Subject: 212 Miller Bay Window

Subject: 212 Miller DRB review comments from Jeff Kahan

Subject: Re: 212 Miller: 2 code issues

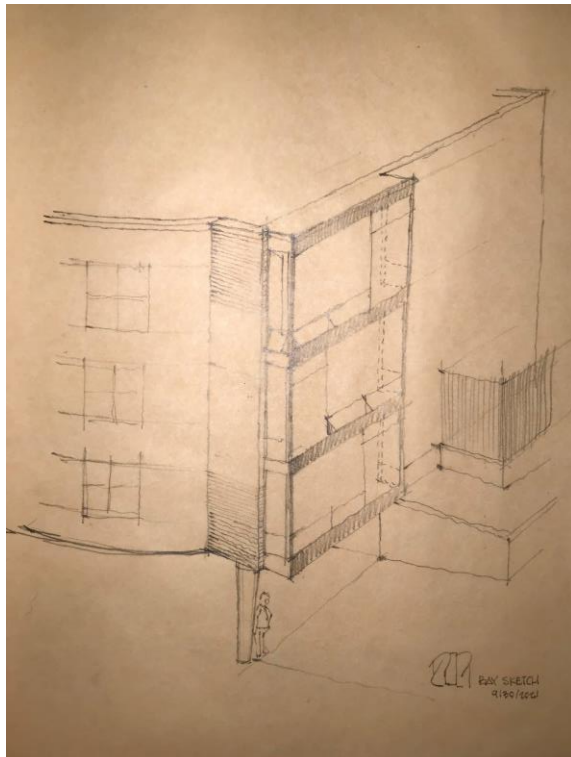
Need some help please. Do you all believe this is not a bay window because of the contemporary articulation of the three-story bay element projecting out 2 feet as the UDC allows? I need to know the issue to solve it to compliance.

So, shooting in the dark, but trying to move this towards resolution; Here is a sketch perspective showing the bay window inset from the corner a brick stretcher length and with glass/windows on three sides. Is this a bay window acceptable to planning's mind?
